STAFF RECOMMENDATION

1207 Shelby Avenue

August 19, 2015

Application: New construction-outbuilding/detached accessory dwelling unit (DADU);
Setback determination

SITE PLAN

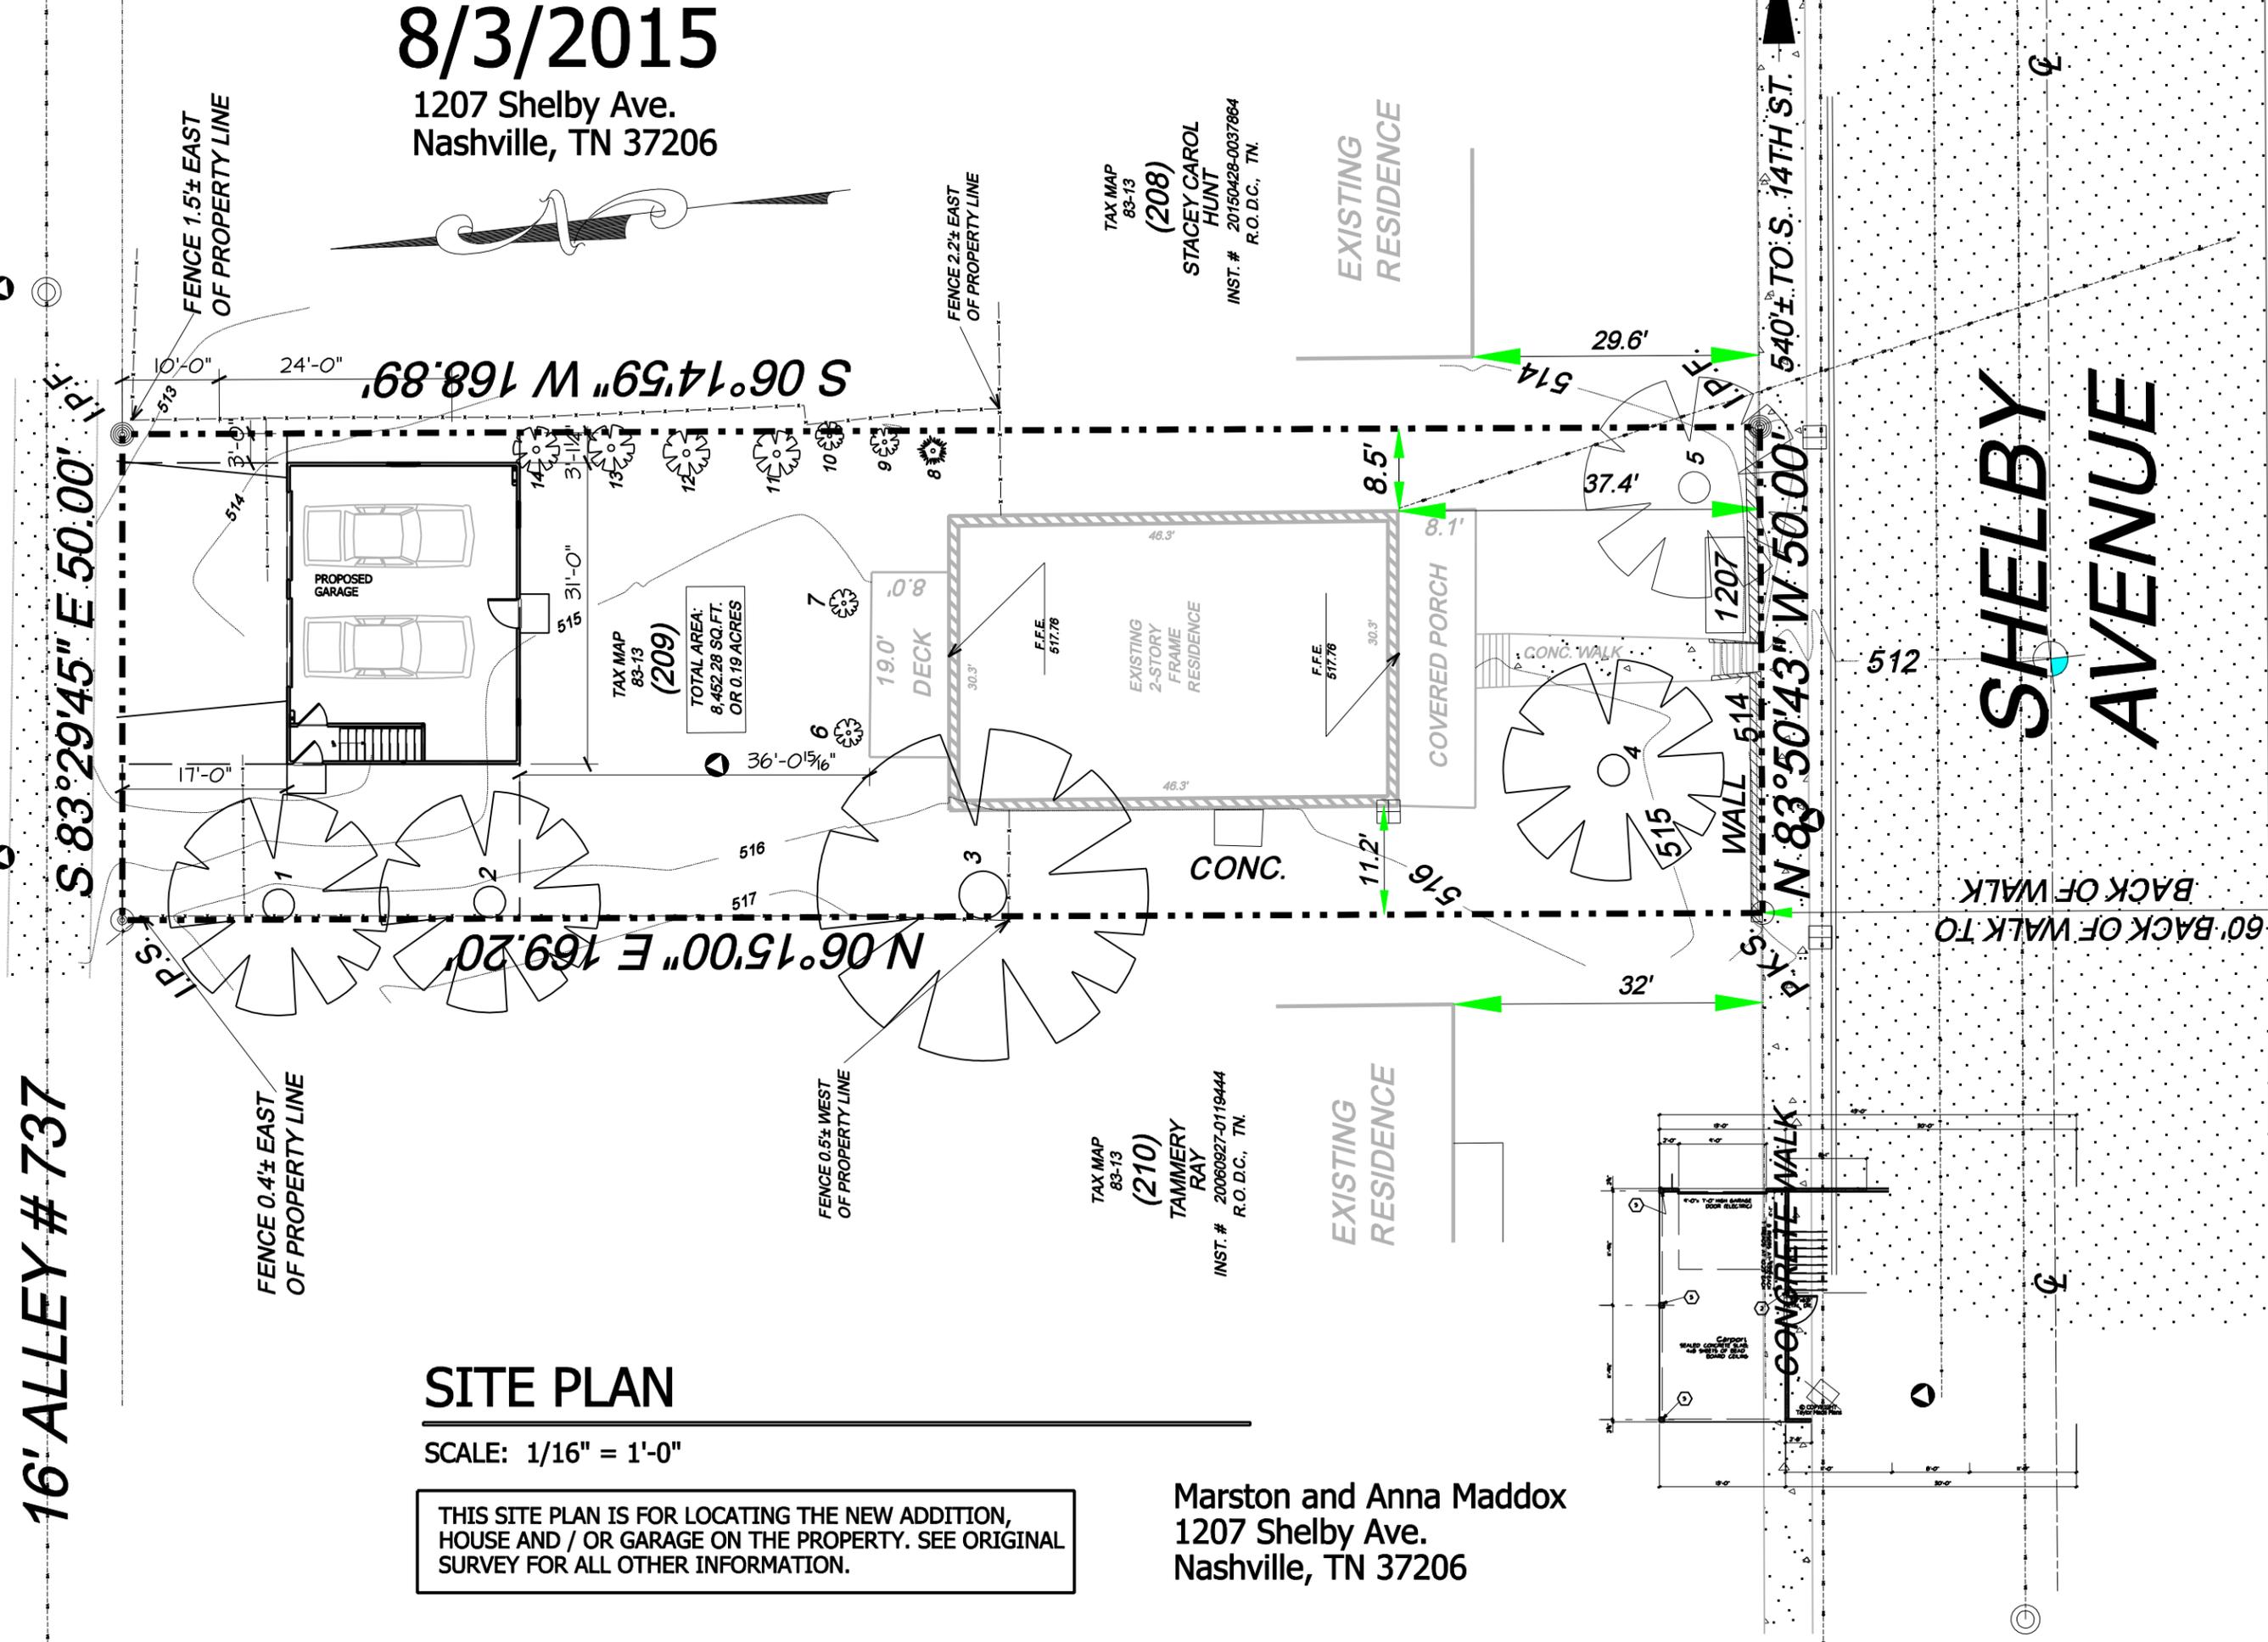
The new outbuilding does require a reduction to the rear and side setbacks. When an outbuilding has a footprint greater than seven hundred square feet (700 sq. ft.), base zoning requires that the structure be located twenty feet (20’) from the rear property line and five feet (5’) from the side property lines. The applicant is proposing to locate the structure three feet (3’) from the side property line, and seventeen feet (17’) from the rear property line. Staff finds that the proposed rear setback is appropriate because historically, outbuildings were located close to the rear property line. A seventeen foot (17’) rear setback is appropriate for the lot. However, staff recommends that the structure be relocated so that it does meet the five foot (5’) side setback. Because of the larger footprint of the structure and its use, a five foot (5’) side setback is more appropriate than a three foot (3’) side setback. The Commission has regularly made determinations for rear setbacks of DADUs but has required that the side setbacks meet bulk zoning standards.

1. Staff receive a restrictive covenant for the detached accessory Dwelling unit;
2. The structure be placed a minimum of five feet (5’) from the side property lines;
3. Staff approve the final details, dimensions and materials of windows and doors prior to purchase and installation; and,
4. Staff approve the roof color and masonry color, dimensions and texture.
